## PRODUCT / PROCESS CHANGE NOTIFICATION

1.1 Company	 STMicroelectronics International N.V
1.2 PCN No.	MDG/24/14291
1.3 Title of PCN	ST Calamba (Philippines) additional assembly plant for STM32MP15x product in BGA10x10, BGA18x18 packages
1.4 Product Category	STM32MP15x products in LFBGA18X18 and TFBGA10X10
1.5 Issue date	2024-02-09

## PRODUCT/PROCESS CHANGE NOTIFICATION PCN14291– Additional information

### ST Calamba (Philippines) additional assembly plant for STM32MP15x product in BGA10x10, BGA18x18 packages

##### BGA10x10 package

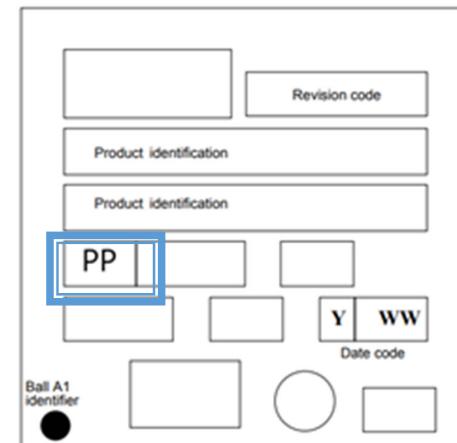
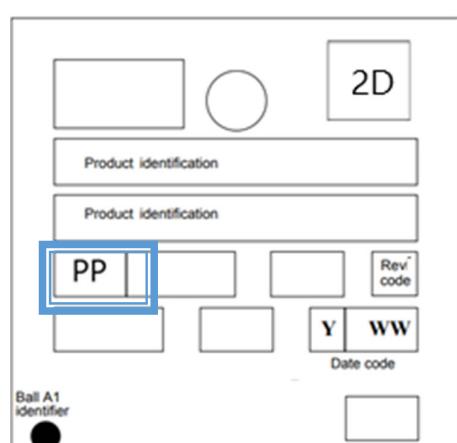
(TFBGA 10X10 257L)	Current condition	New condition
Assembly site	AMKOR ATK (Korea)	ST Calamba (Philippines)
Glue (no change)	2025D ABLESTIK	
Molding compound <sup>(1)</sup>	GE110-LL	GE 100LF1-2
Substrate core	HL832NXA (HS)	Showa Denko MCL-E-679FGB (SM)
Solder ball (no change)	SACN125-5 (0.30mm)

(1) Package darkness changes depending on molding compound. Pin1 identifier can change in terms of form and positioning. Marking position and size could be different upon assembly site, without any loss of information.

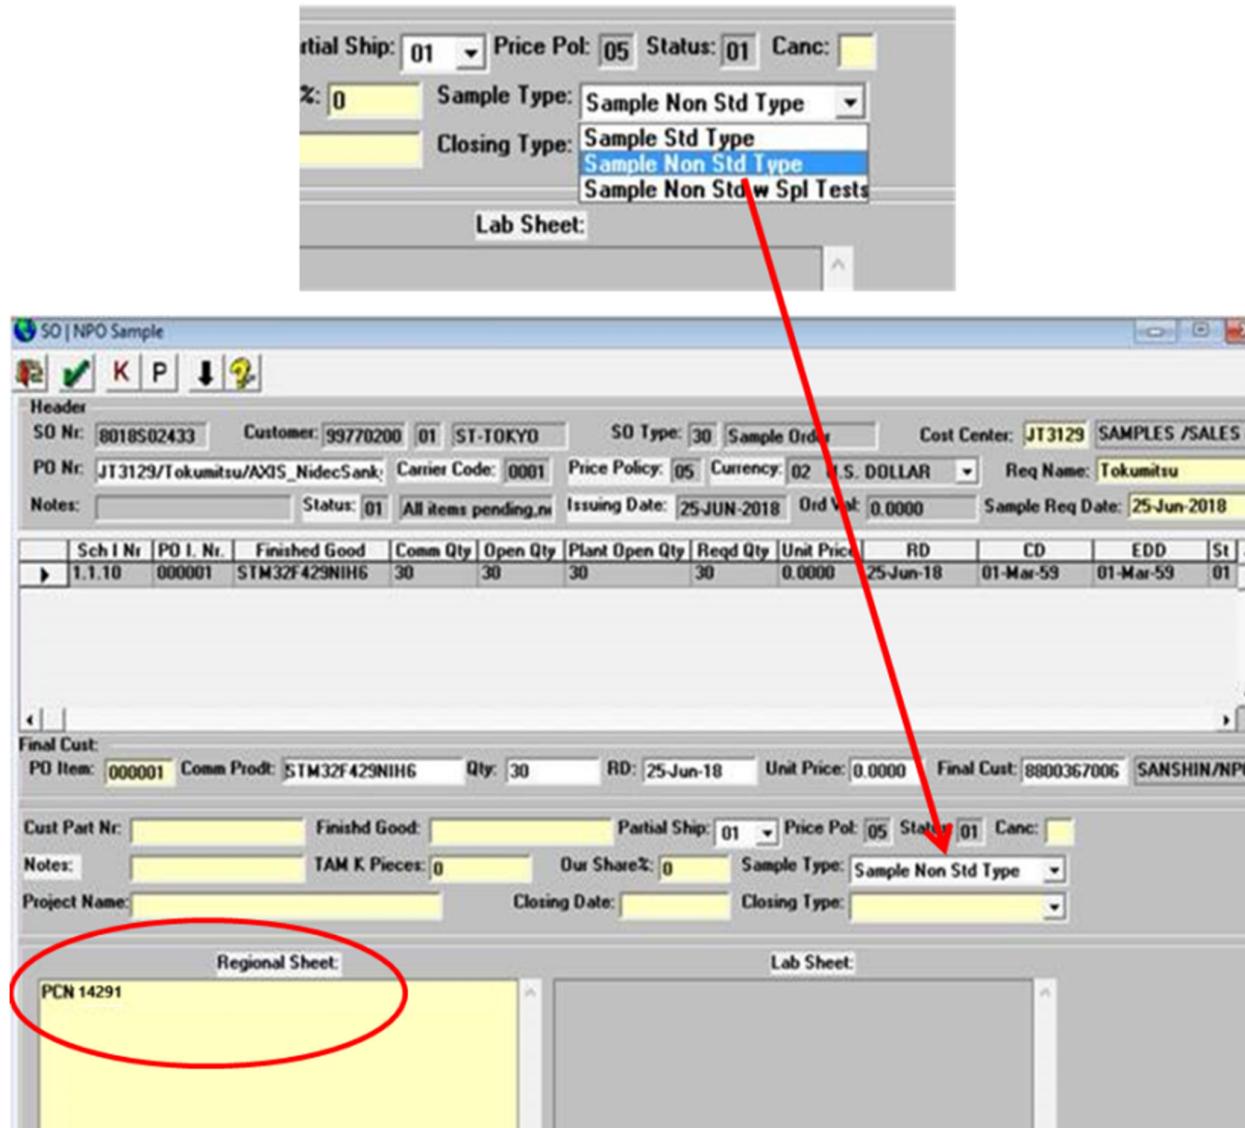
Marking	Before	After
BGA 18X18 BGA 10x10		
PP code	<b>HP:</b> Amkor ATK (Korea) <b>AA:</b> ASE KaoHsiung (Philippines)	<b>78:</b> ST Calamba (Philippines)

**Y WW code** indicates Year Week (manufacturing date)

**PP code** indicates assembly traceability plant code.
